August 3, 1984

HOPE CREEK GENERATING STATION  
DOCKET NO. 50-354  
DRAFT SAFETY EVALUATION REPORT  
OPEN ITEM STATUS

In addition, enclosed for your review and approval (see Attachment 4) are the resolutions to the Draft SER open items, FSAR question responses and structural geotechnical audit item responses, listed in Attachment 3.

FIGURE A-13-31

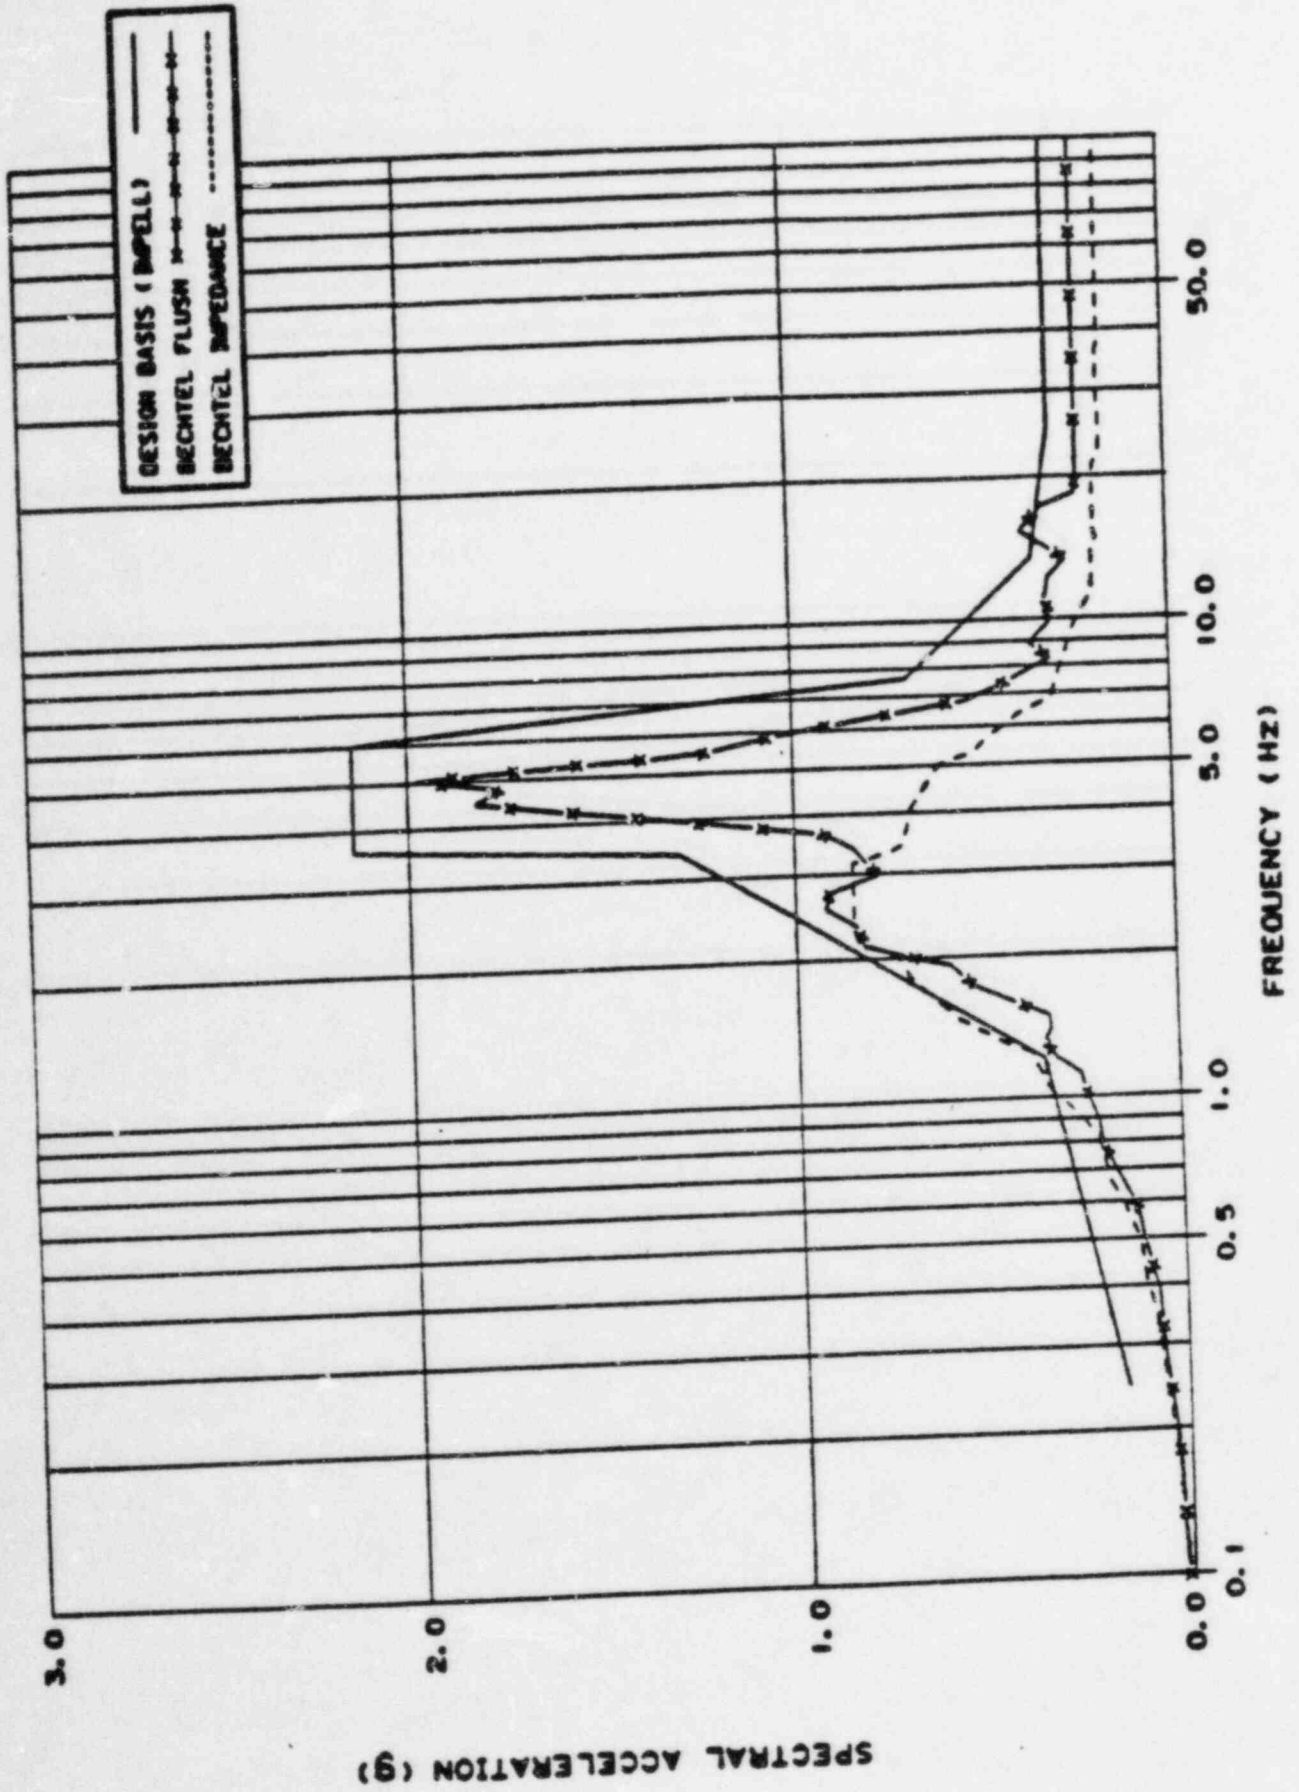
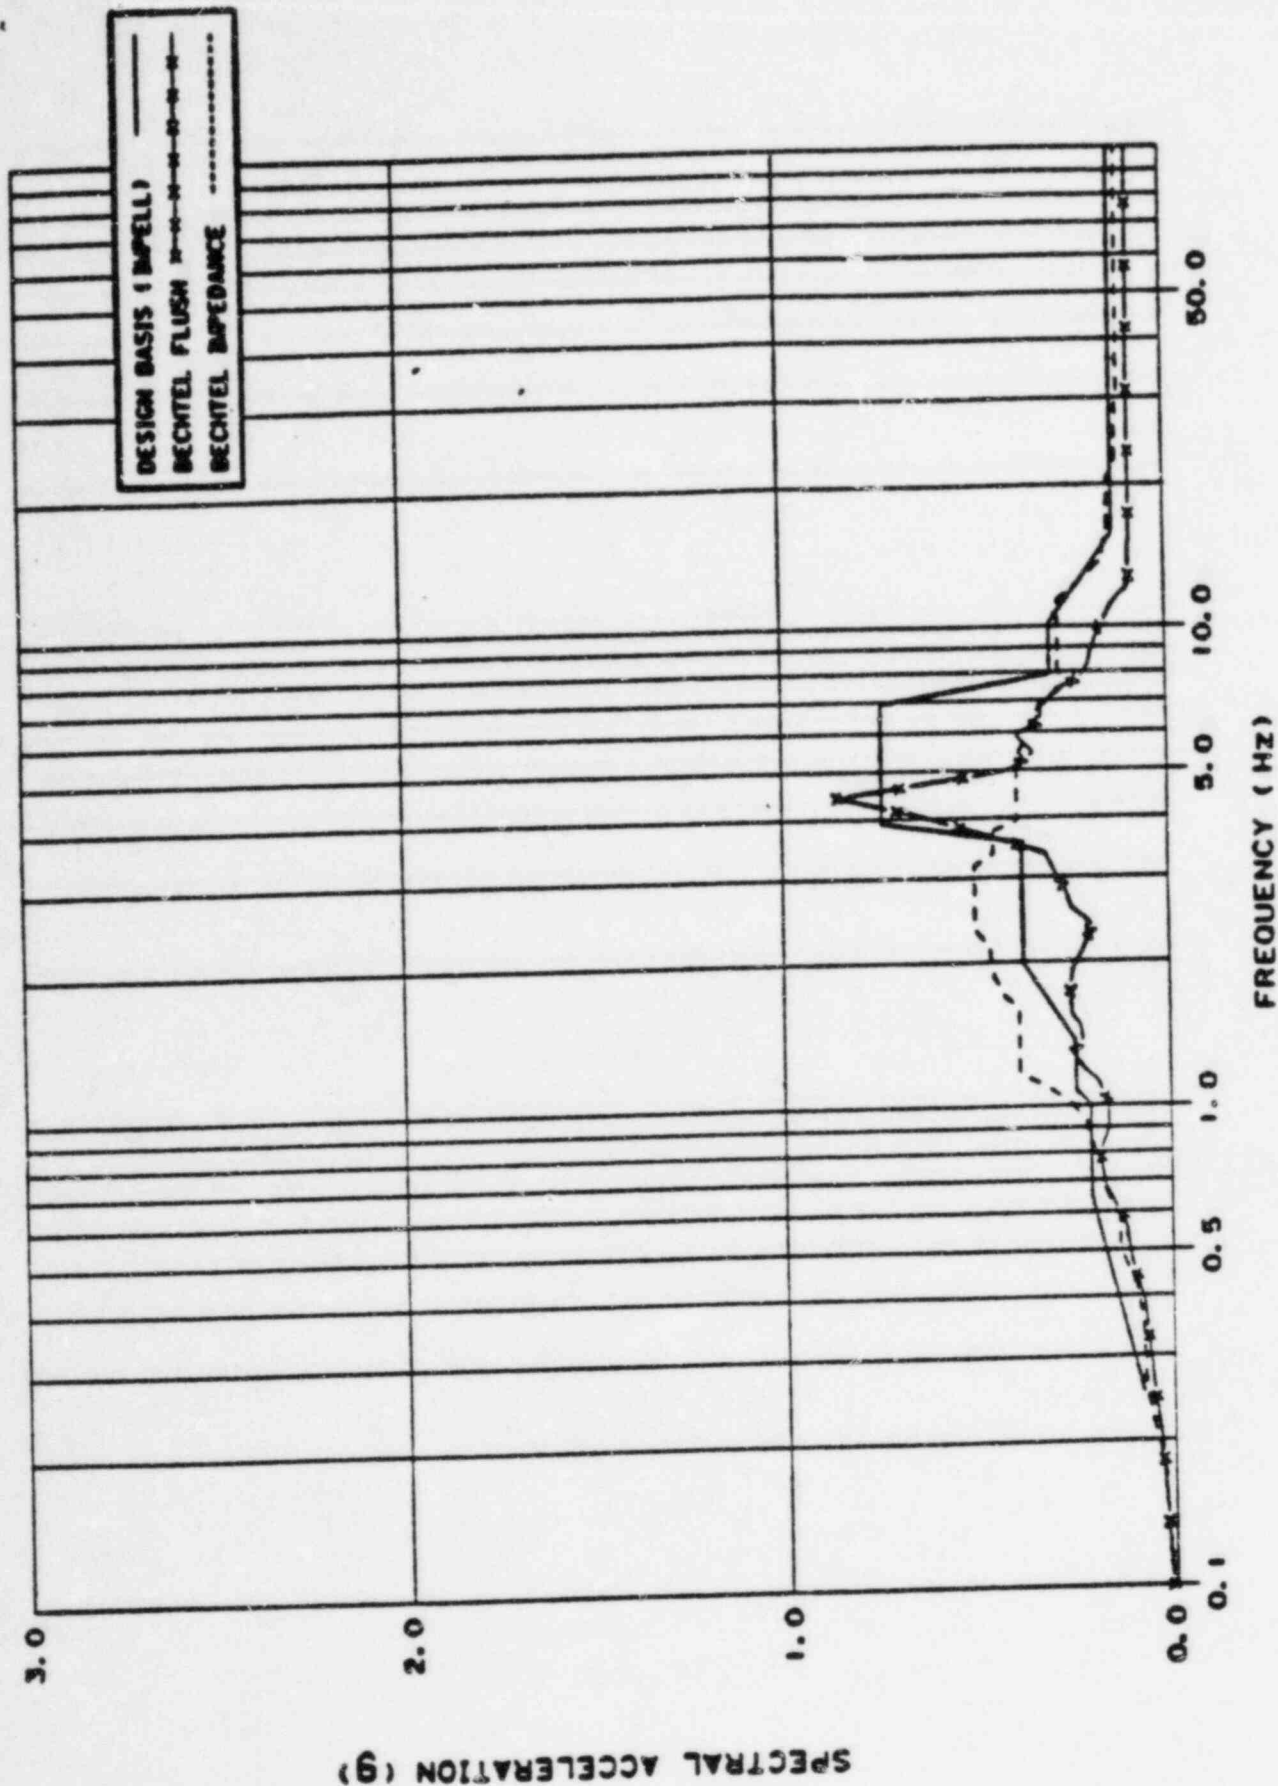
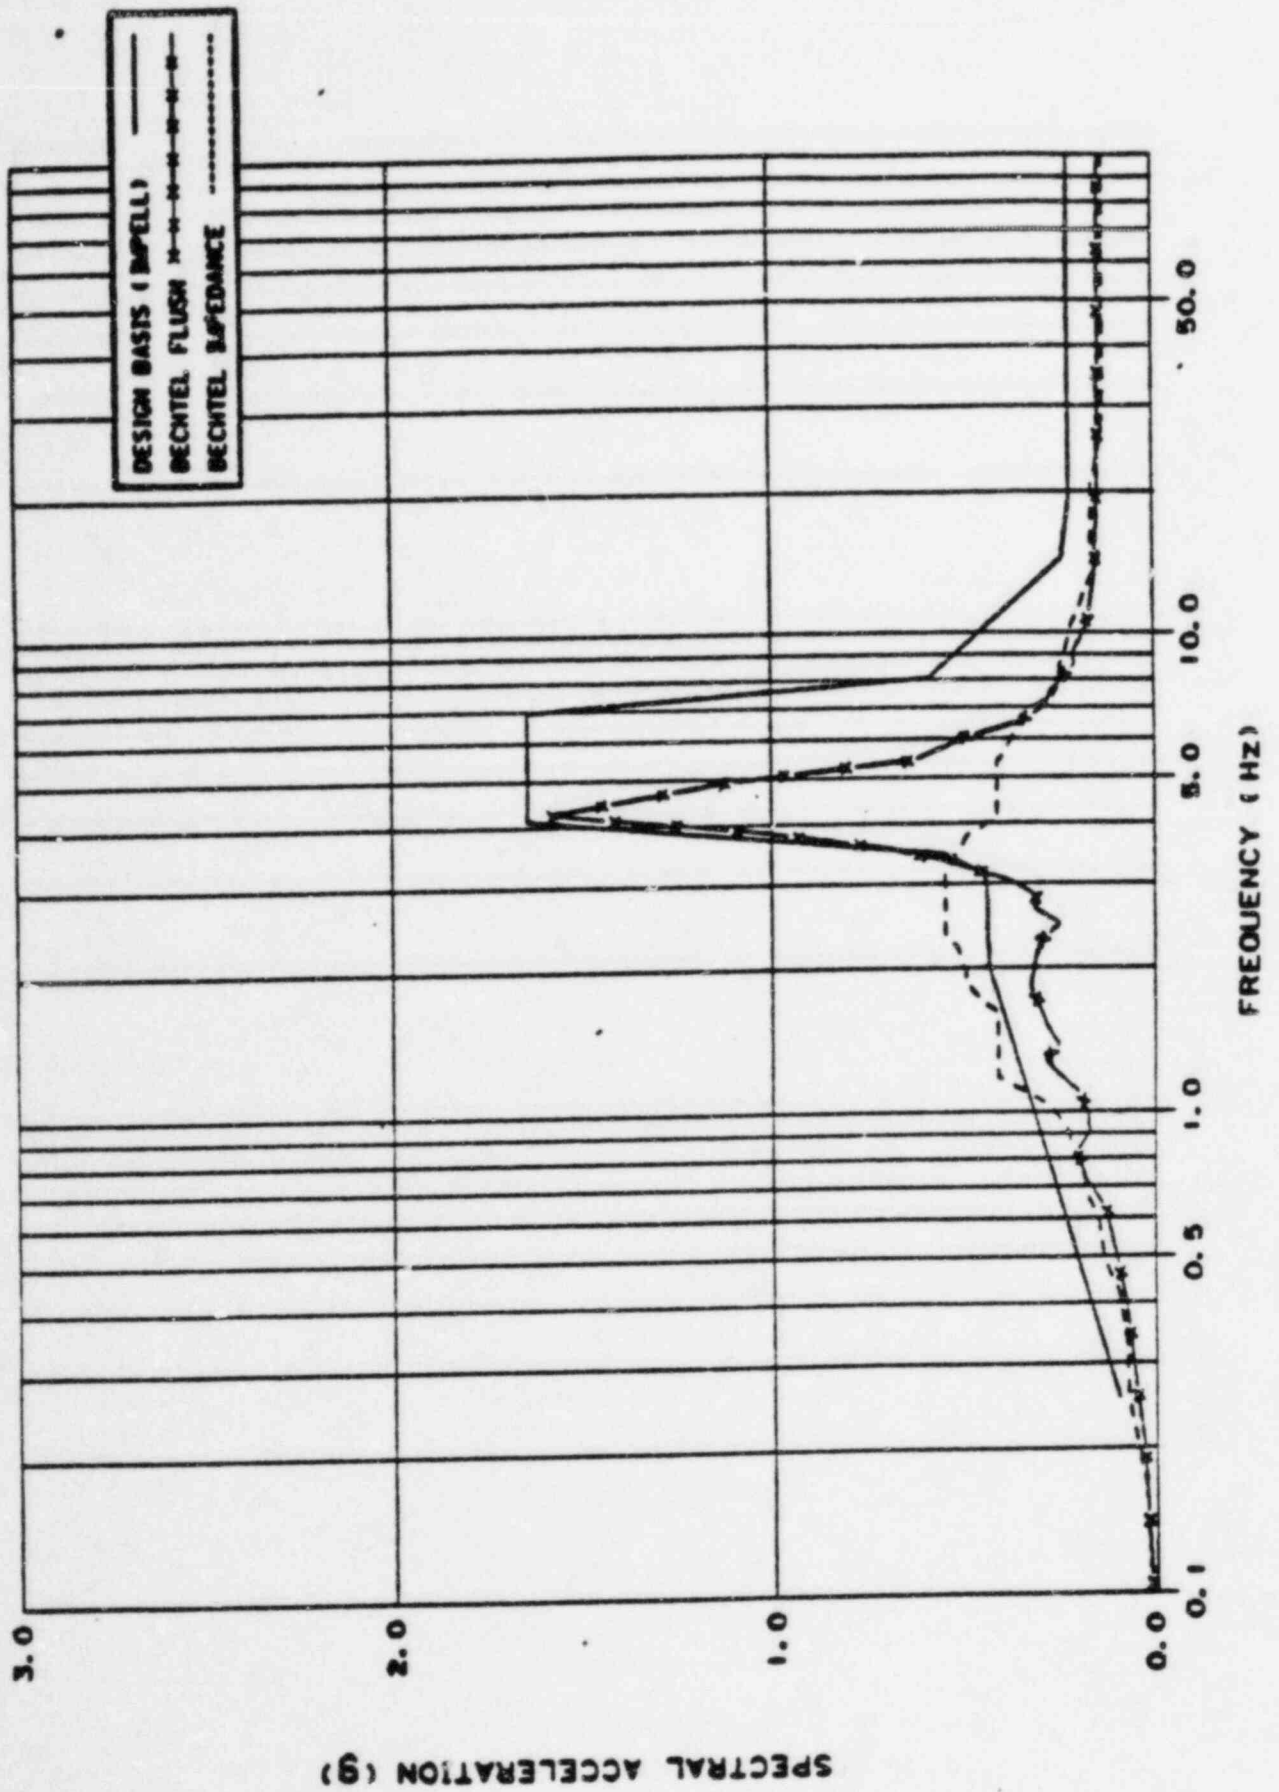
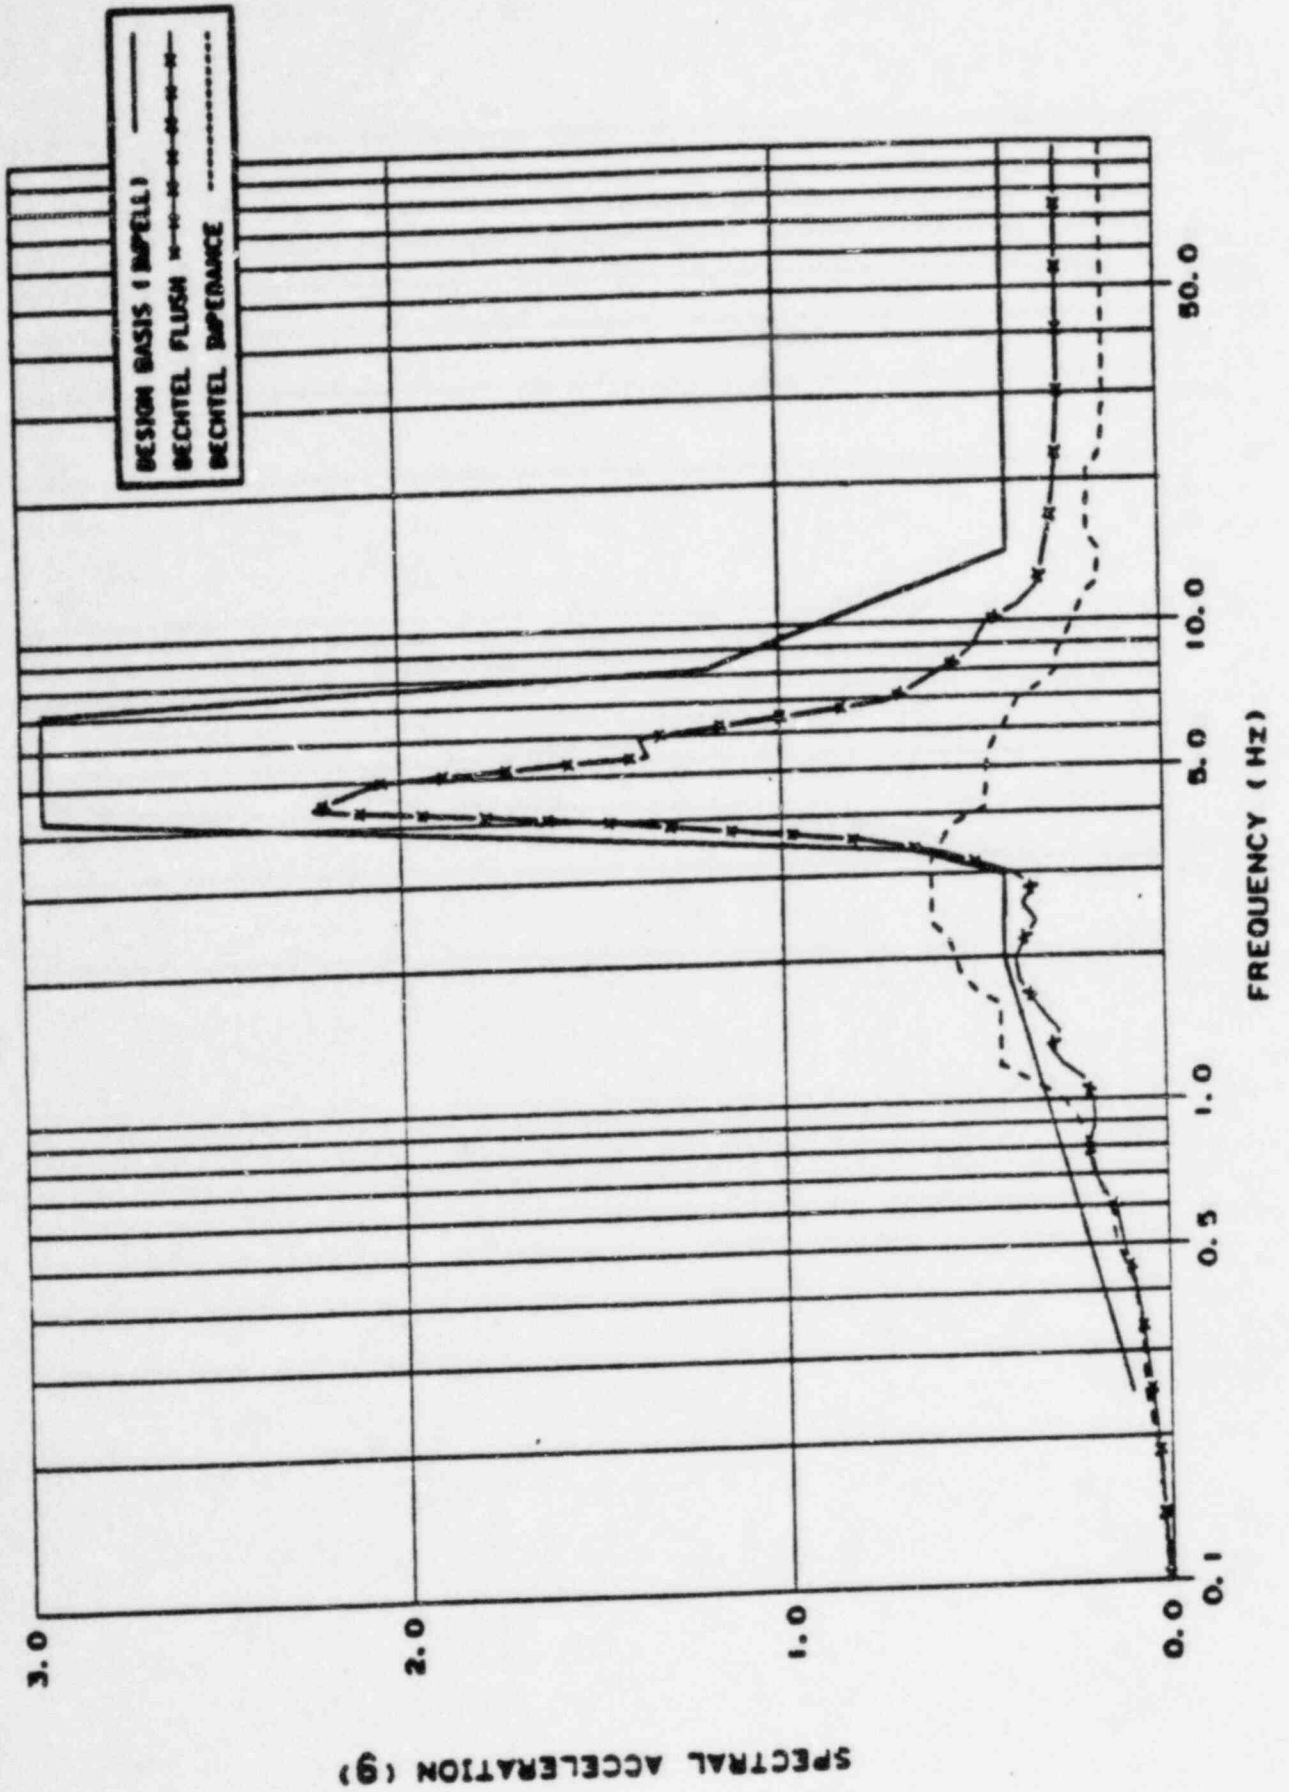
Question: Provide comparison of Bechtel Independent Verification Results with the Design Basis Results.

Figures A-13-2 to A-13-37 show the comparison of the response spectra (2% damping) obtained from the above three seismic soil-structure interaction analyses. Discussions of these comparisons are as follows:

Bechtel's independent soil-structure interaction analyses are performed using the computer code FLUSH. The results of independent finite element analyses are in reasonable agreement with those of the design basis analyses. As can be seen from Figures A-13-2 through A-13-37, the horizontal response spectra obtained from the independent finite element analyses are generally enveloped by those obtained from the design basis analyses except for the frequency range lower than 2 Hz. The vertical response spectra showed some exceedances at the frequency range of 18 Hz. These exceedances are listed in Table A-13-1.

The peak spectral accelerations obtained from the impedance approach analyses are generally lower than those obtained from the design basis analyses. However, these response spectra are not completely enveloped by those obtained from the design basis analysis, especially in the frequency range between 1.0 and 3.5 Hz. Also, there are some local exceedances in the higher frequency range, as shown in Figures A-13-2 through A-13-37.
